1990 Corvette: Service Bulletin: Clutch Apply Plate Material Changed to Powdered Metal

Subject: CLUTCH APPLY PLATE MATERIAL CHANGED TO POWDERED METAL

Model and Year: 1990 ALL CARS, TRUCKS, VANS WITH 4L60 (700-R4) AUTOMATIC TRANSMISSION

Bulletin Number: 90-189-7A - (03/06/1990)

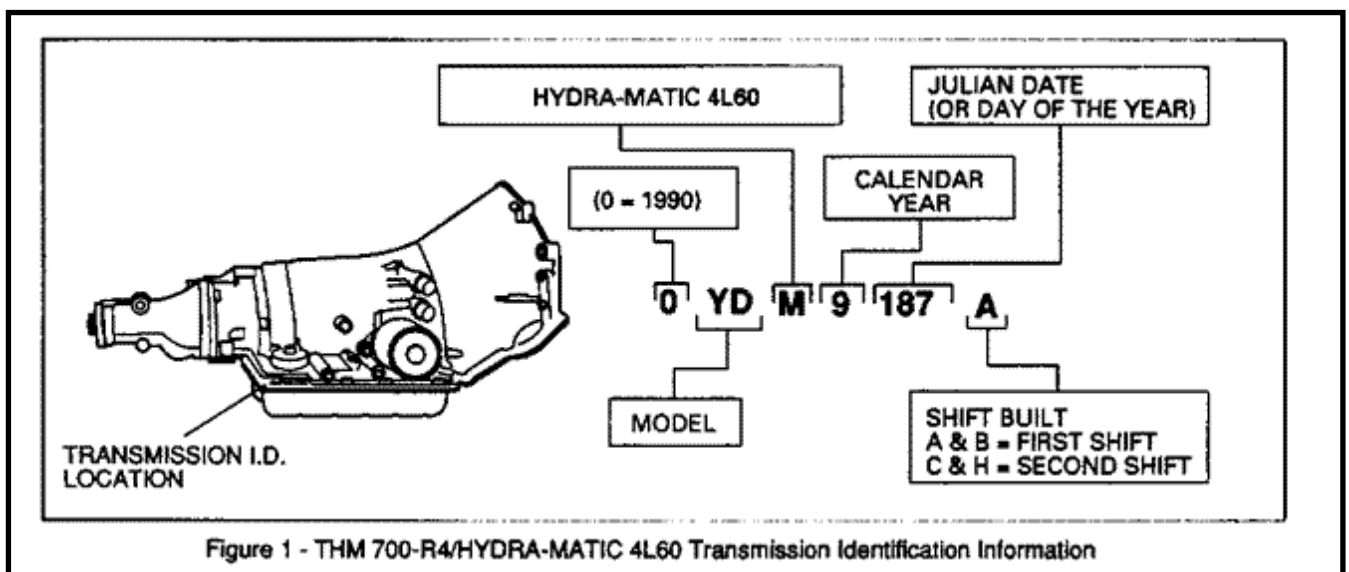
This bulletin covers a material change for the forward and 3-4 clutch apply plates. These clutches will now contain apply plates manufactured from powdered metal instead of steel.

The following dates show when changes went into effect: (Figure 1)

Apply Plate Start of Production Date

Forward January 25, 1990 (Julian Date 025)

3-4 January 29, 1990 (Julian Date 029)

The new powdered metal plates are interchangeable with the current steel plates. Dimensions of the new powdered metal plates are the same as the steel plates. Powdered metal plates will appear darker in color than previously produced steel plates.

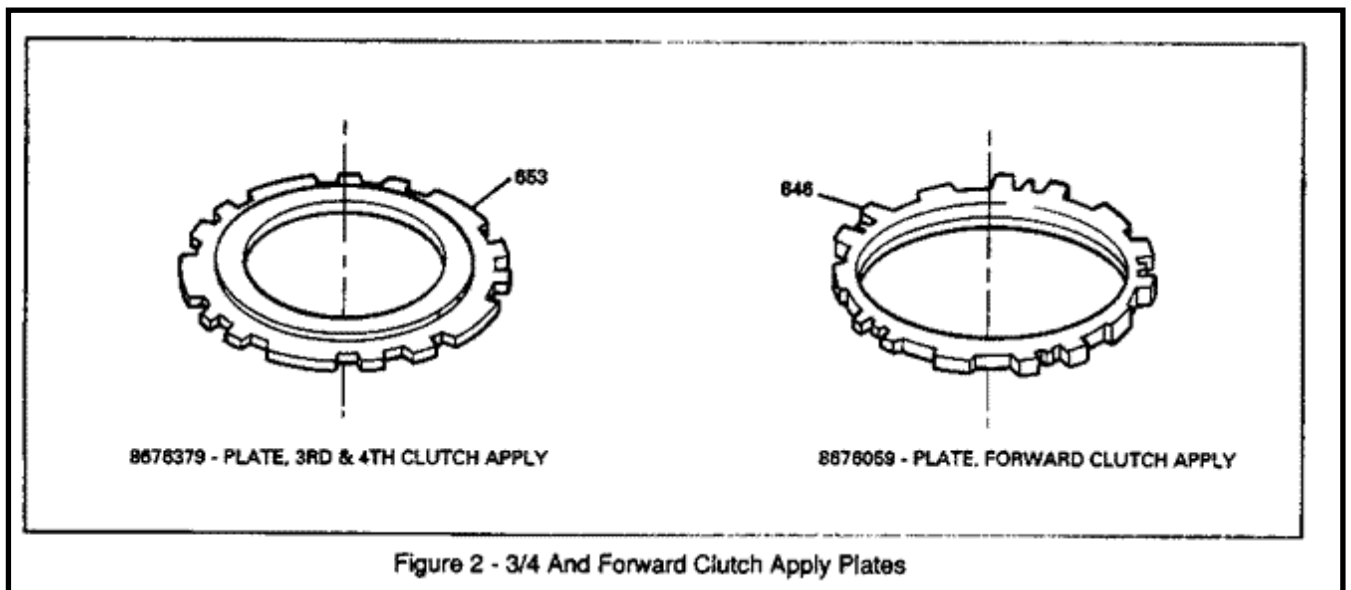
Part numbers have changed. (Figure 2)

Part Number Description

8663785 Apply Plate - Forward Clutch (steel)

8667423 Apply Plate - 3-4 Clutch (steel)

8676059 Apply Plate - Forward Clutch (powdered metal)

8676379 Apply Plate - 3-4 Clutch (powdered metal)

When GMSPO stock of steel plates is used up, powdered metal plates will be available for service.
